AP1000 GSI-191 Issue Resolution Recent Informal NRC Questions

December 15, 2009

Dec 15, 2009 Meeting With NRC on Remaining Issues on AP1000 GSI-191

Q2b – Justify Use Of Fuel Assembly Without Heated Rods (High Velocity)

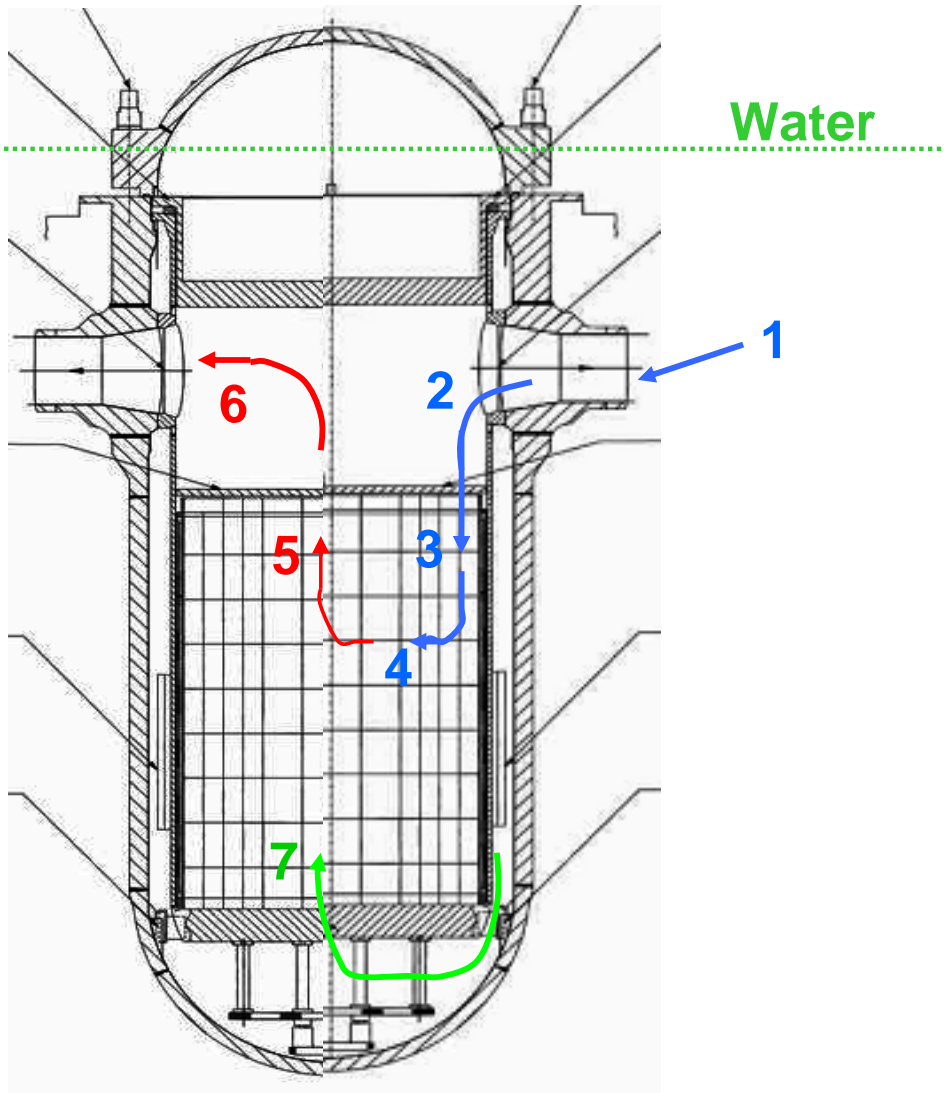
- NRC Question
 - The fuel assembly tests were performed with 1/3-length scale model with isothermal conditions. Provide justifications on how it can be scaled up to a full length with boiling in the upper portion of the fuel assembly.
- Response will be provided in 4 parts
 - a. Use of 1/3-length FA
 - b. Boiling impact on dP due to higher velocity
 - c. Boiling impact on BA/TSP plateout
 - d. Boiling impact on AIOOH dP characteristics

- Boiling does not cause excessive dP

- Debris can enter upper portion of fuel from HL and flow down through low power, periphery FAs, then cross over to high power central FAs (depicted in next slide)
